# CITY OF TAMPA

## ADDENDUM 3

**DATE: September 13, 2017**

Contract 17-C-00011; Howard F. Curren AWTP Final Sedimentation Tanks Air Piping Improvements

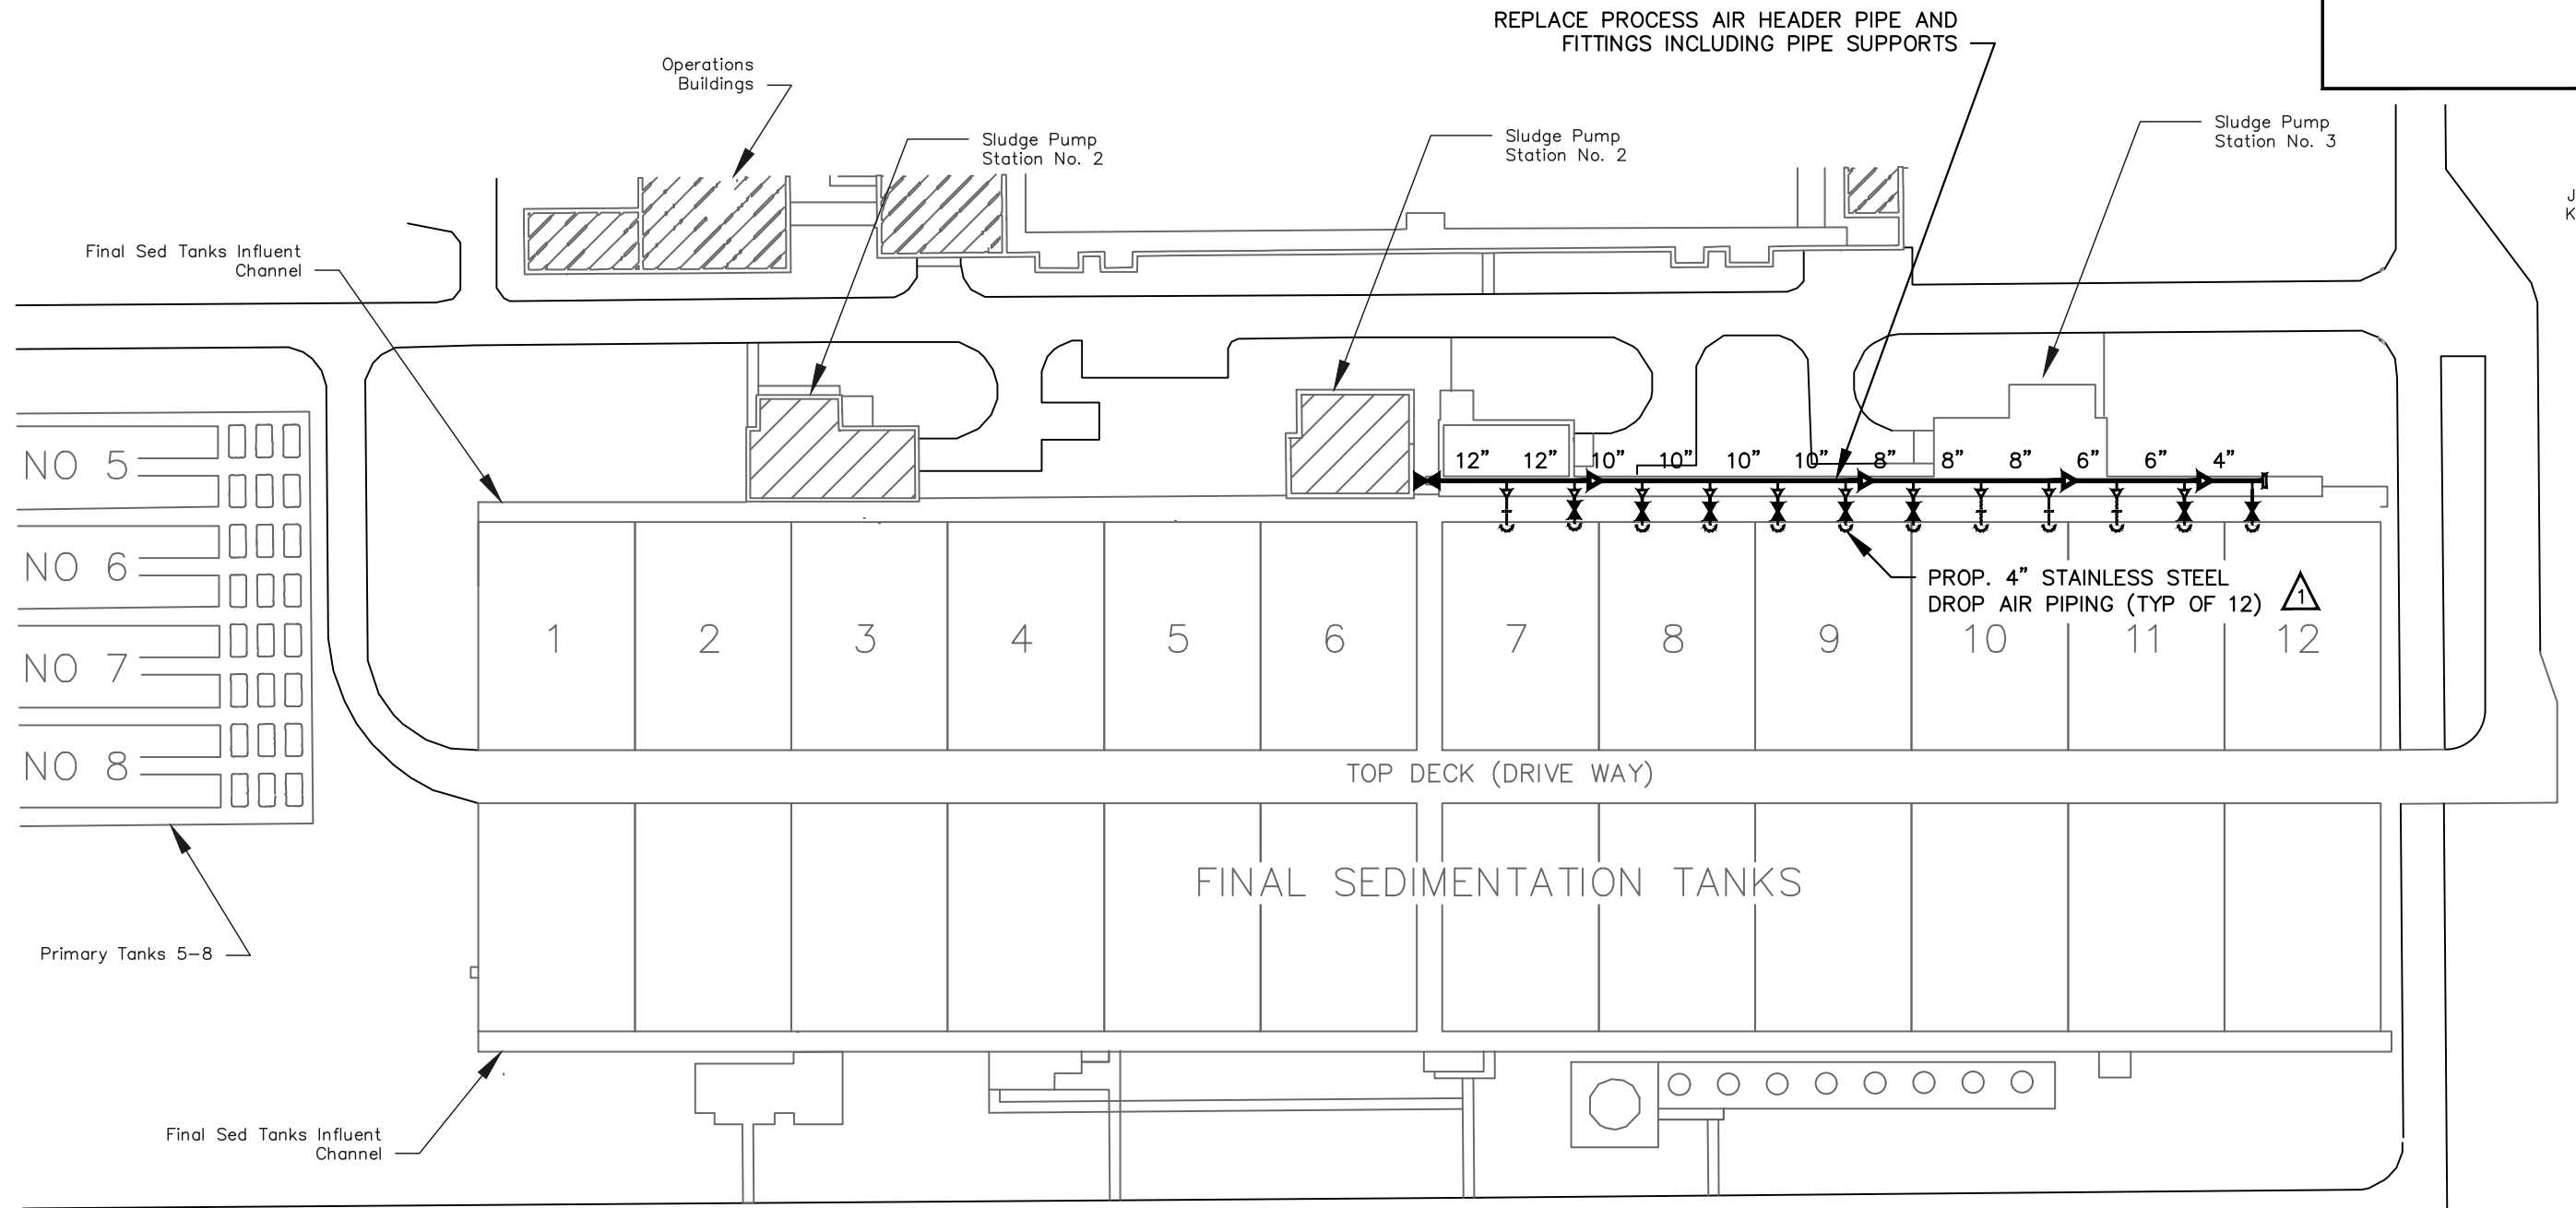
8. CONTRACTOR SHALL REPLACE EXISTING (25) PIPE ANCHORS WITH 316L STAINLESS STEEL PIPE ANCHORS – VARIOUS SIZES. (SEE TABLE 1 AND DETAILS)
- △ 9. CONTRACTOR SHALL REPLACE AN EXISTING 12" BUTTERFLY VALVE AS DESIGNATED ON THE PLANS. BUTTERFLY VALVE SHALL BE DEZURK HIGH PERFORMANCE (BHP) OR APPROVED EQUAL. VALVE SHALL BE PROVIDED WITH A MANUAL HANDWHEEL OPERATOR. REPLACEMENT OF THIS VALVE WILL REQUIRE PROCESS AIR SHUTDOWN. DURATION OF SHUTDOWN SHALL NOT BE MORE THEN 2 HOURS AND A MINIMUM OF FIVE WORKING DAYS NOTICE IS REQUIRED.

- △ 10. CONTRACTOR SHALL REPLACE EXISTING 4" SUMP PUMP DISCHARGE AND FLANGE WITH SCHEDULE 40 TYPE 316 STAINLESS STEEL AT LOCATION SHOWN ON PLANS. INSULATING FLANGE SHALL BE USED TO CONNECT TO EXISTING 4" PIPE.

15. NORMAL WORKING HOURS SHALL BE WEEKDAYS FROM 7:30 AM TO 4 PM UNLESS OTHERWISE APPROVED BY THE ENGINEER/INSPECTOR.
- △ 16. CONTRACTOR SHALL REPLACE (12) EXISTING 4" BUTTERFLY VALVES WITH DEZURK HIGH PERFORMANCE BUTTERFLY VALVES (BHP) OR APPROVED EQUAL. VALVES SHALL BE EQUIPPED WITH ADJUSTABLE LEVERS.

- △ 17. PIPE WELDING SHALL BE TESTED BY VISUAL INSPECTION. THE VISUAL INSPECTION SHALL BE PERFORMED BY A THIRD PARTY, CERTIFIED WELD INSPECTION COMPANY THAT IS EXTREMELY FAMILIAR WITH 316 STAINLESS STEEL WELDS. THE VISUAL INSPECTION SHALL CONSIST OF INSPECTING AND APPROVING THE INITIAL (ROOT) WELDS ON THE FIRST DAY OF WELDING IN ORDER TO ESTABLISH AN APPROVED CRITERIA. FINAL WELD VISUAL INSPECTIONS OF ALL WELDS SHALL ALSO BE PERFORMED. ALL DEFICIENT WELDS AS IDENTIFIED BY THE TESTING COMPANY SHALL BE CORRECTED AND RE-INSPECTED AT NO ADDITIONAL COST TO THE CITY. ALL COSTS ASSOCIATED WITH THE VISUAL WELD INSPECTION SHALL BE CONTRACTOR'S RESPONSIBILITY.

- △ 18. CONTRACTOR SHALL PERFORMED A POST-INSTALLATION TEST OF THE SYSTEM. THE POST-INSTALLATION TEST SHALL CONSIST OF OPERATING THE SYSTEM UNDER LIVE FLOW FOR A 48-HOUR PERIOD AND CHECKING FOR AIR LEAKS. ANY DEFICIENCY IDENTIFIED BY THE TESTING SHALL BE CORRECTED AND RE-TESTED AT NO ADDITIONAL COST TO THE CITY.

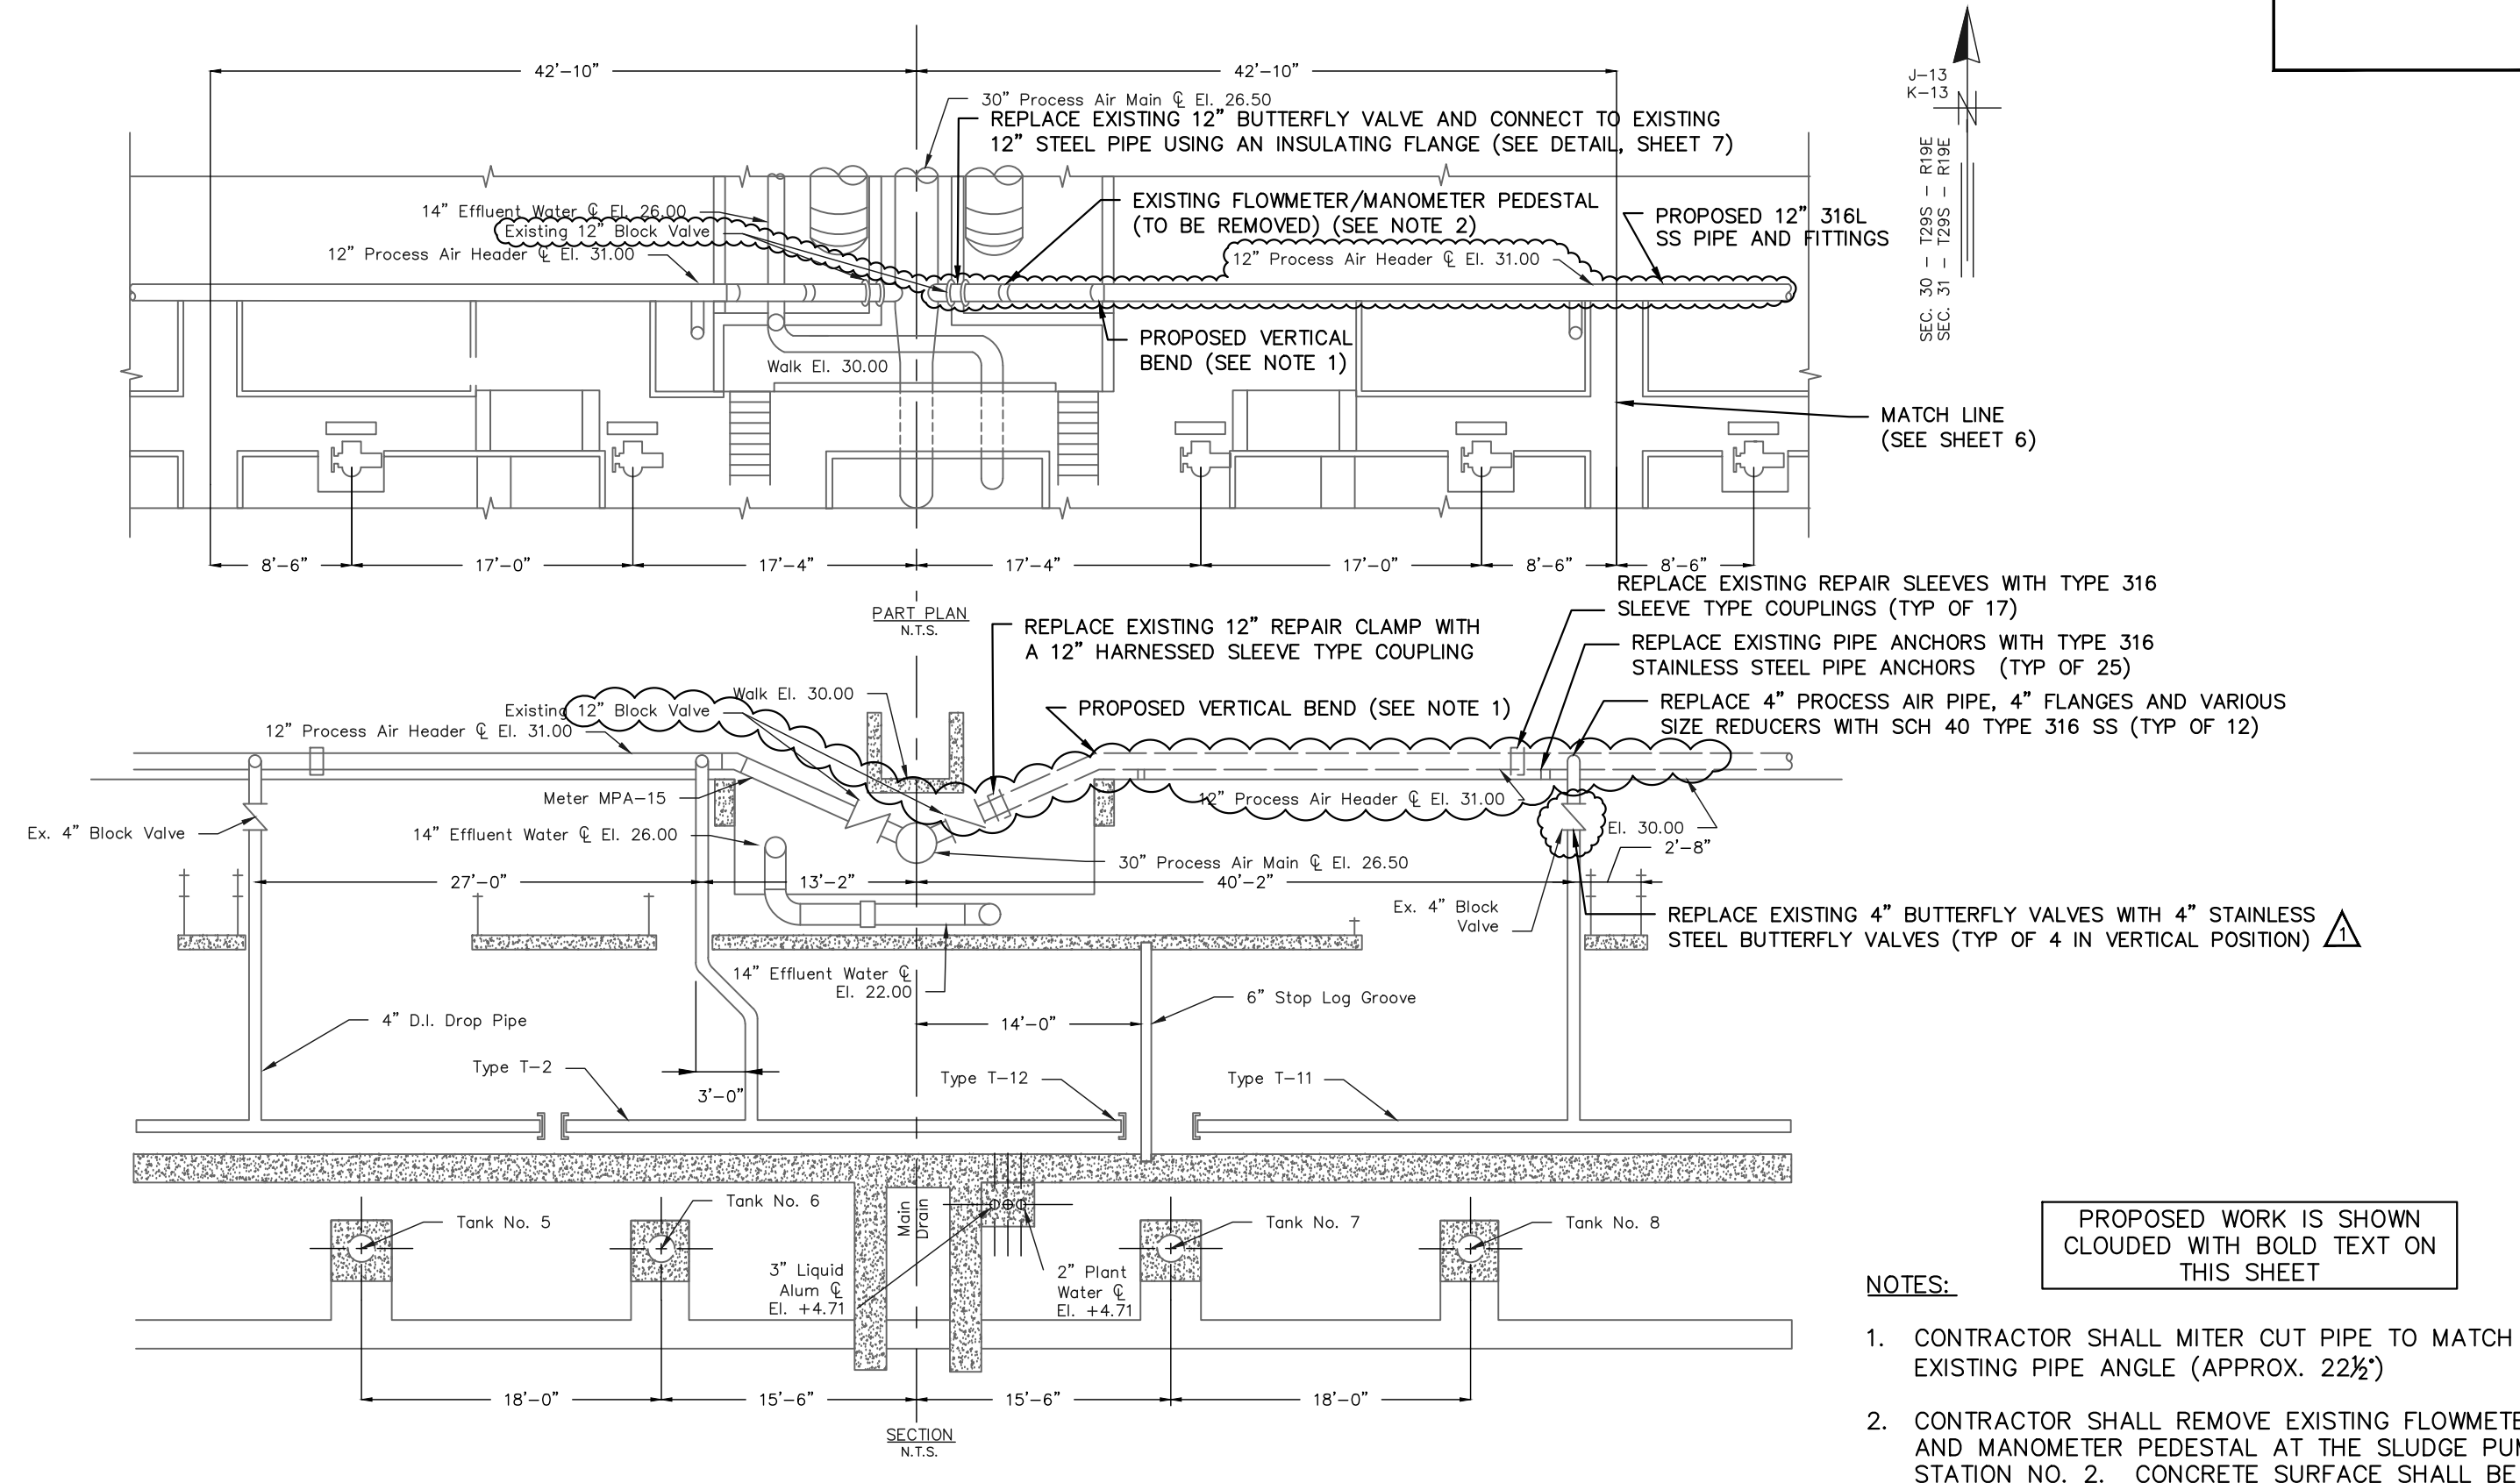
- △1 PROPOSED BUTTERFLY VALVE
- ▷ PROPOSED REDUCER
- ┆ EXISTING 4" 90° BEND DROP PIPE (TO REMAIN)

HOWARD F. CURREN AWWP FINAL SEDIMENTATION TANKS AIR PIPING  
IMPROVEMENTS  
INFLUENT CHANNEL AIR PIPING PROPOSED PLAN & SECTION (2)

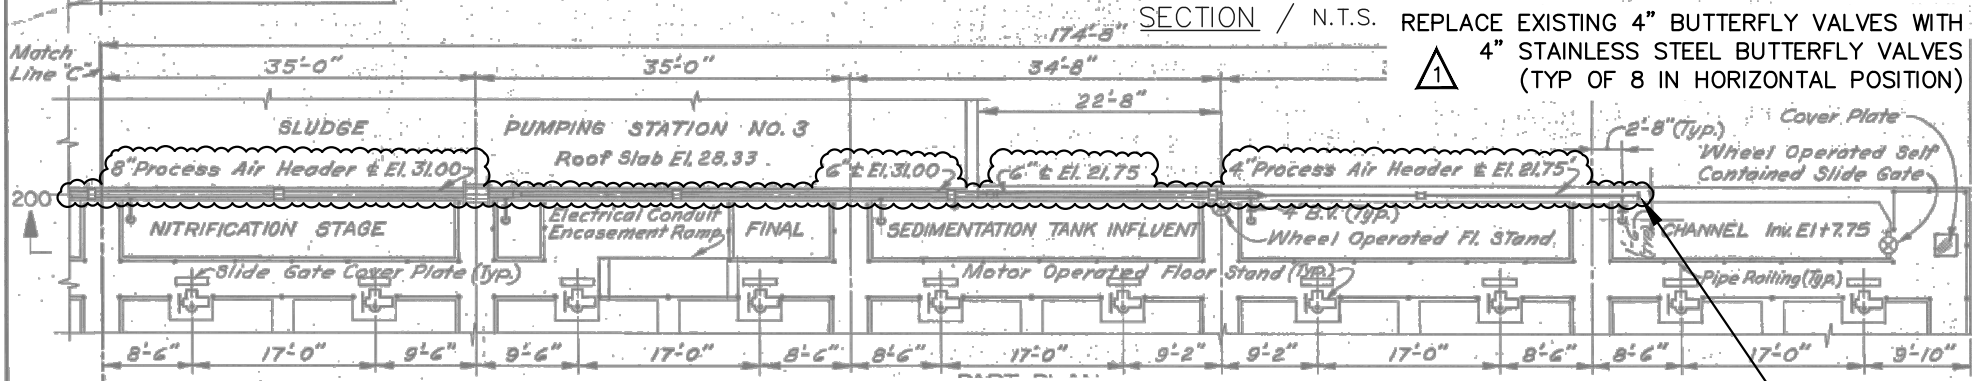
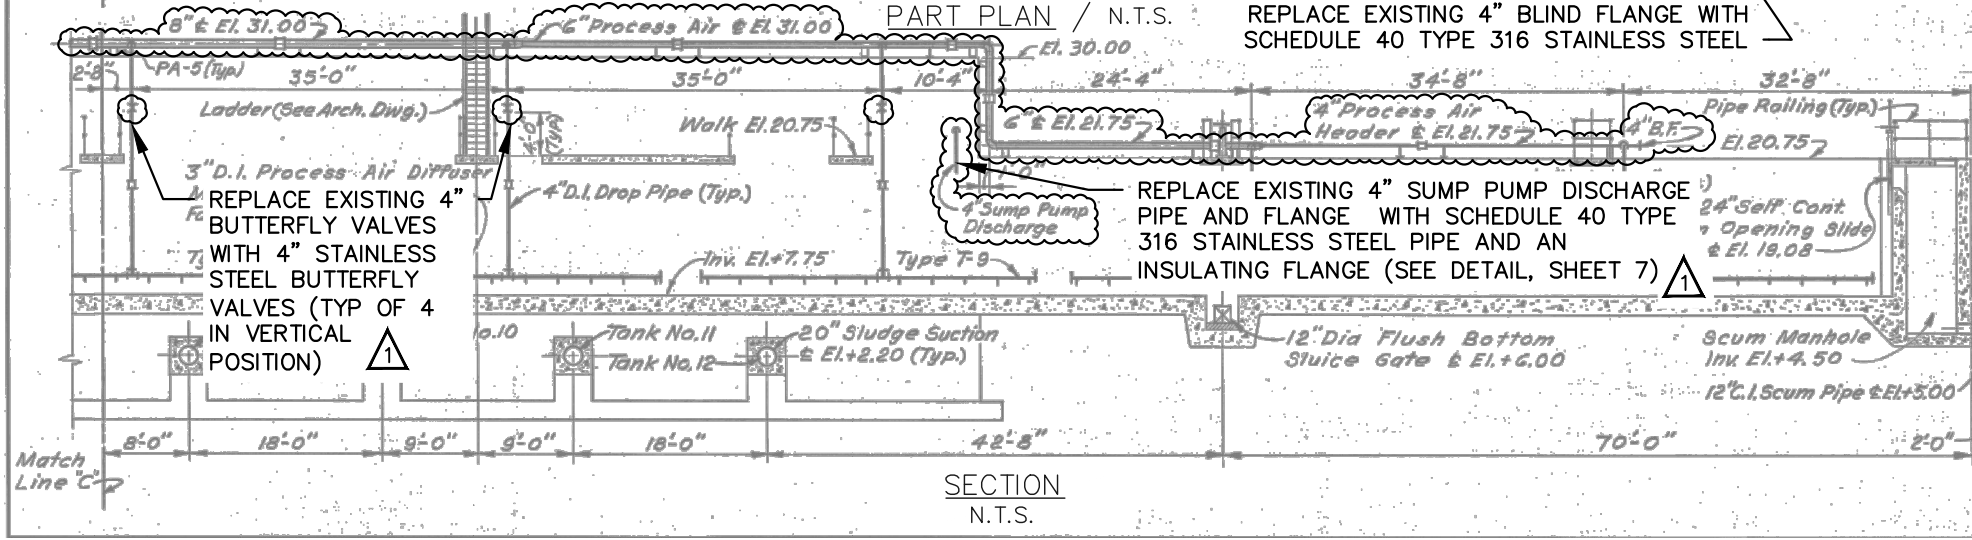
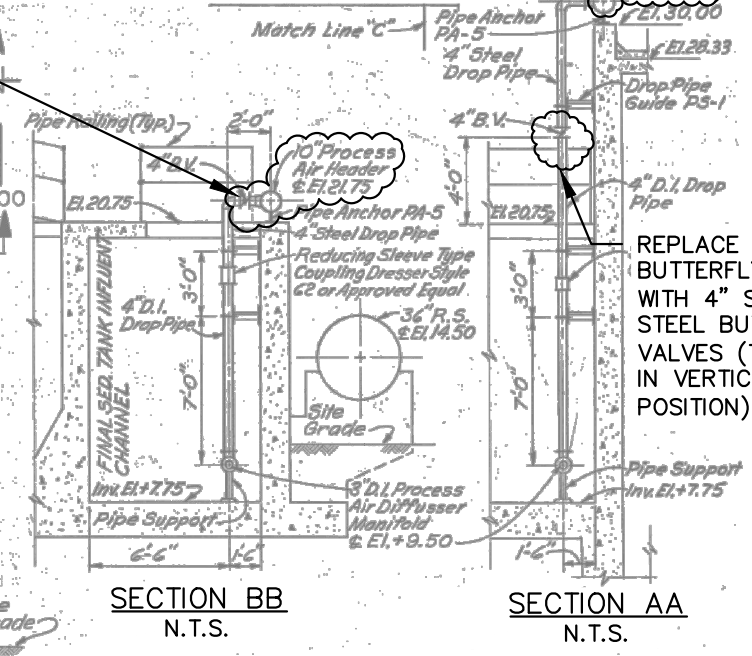
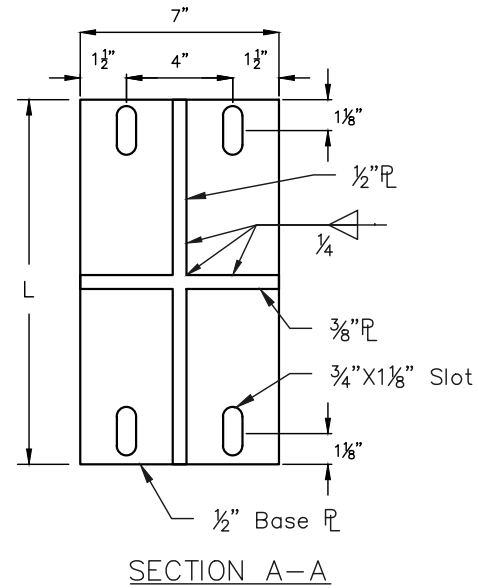
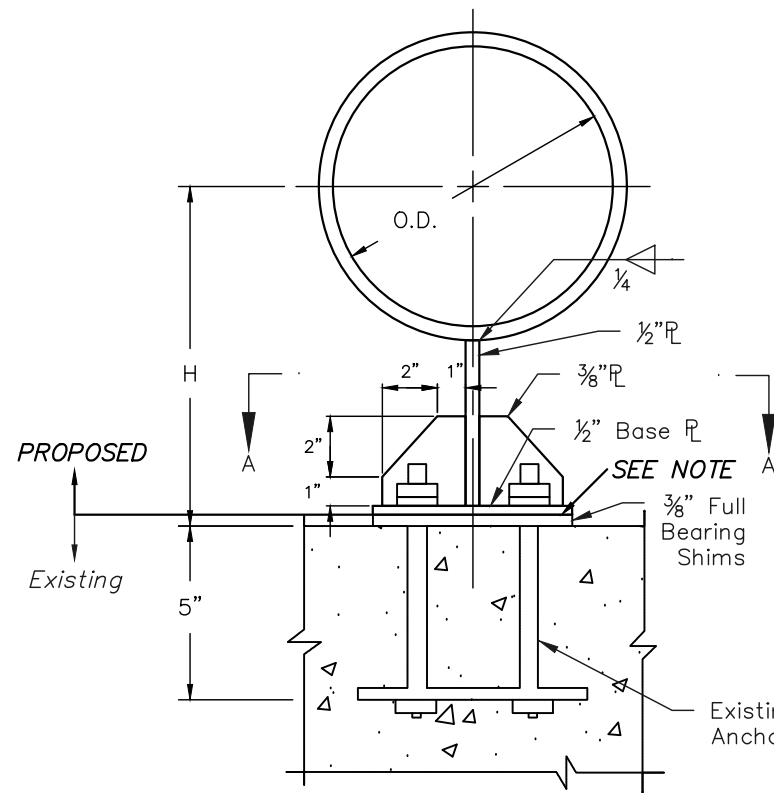
REPLACE EXISTING 4" PROCESS AIR PIPE, 4"  
FLANGES AND VARIOUS SIZES REDUCERS WITH  
SCHEDULE 40 STAINLESS STEEL (TYP OF 12)

REPLACE EXISTING 4" BUTTERFLY VALVES WITH  
4" STAINLESS STEEL BUTTERFLY VALVES  
(TYP OF 8 IN HORIZONTAL POSITION)

REPLACE EXISTING 4"  
BUTTERFLY VALVES  
WITH 4" STAINLESS  
STEEL BUTTERFLY  
VALVES (TYP OF 4  
IN VERTICAL  
POSITION)

REPLACE EXISTING 4" SUMP PUMP DISCHARGE  
PIPE AND FLANGE WITH SCHEDULE 40 TYPE  
316 STAINLESS STEEL PIPE AND AN  
INSULATING FLANGE (SEE DETAIL, SHEET 7)

REPLACE EXISTING 4"  
BUTTERFLY VALVES  
WITH 4" STAINLESS  
STEEL BUTTERFLY  
VALVES (TYP OF 4  
IN VERTICAL  
POSITION)
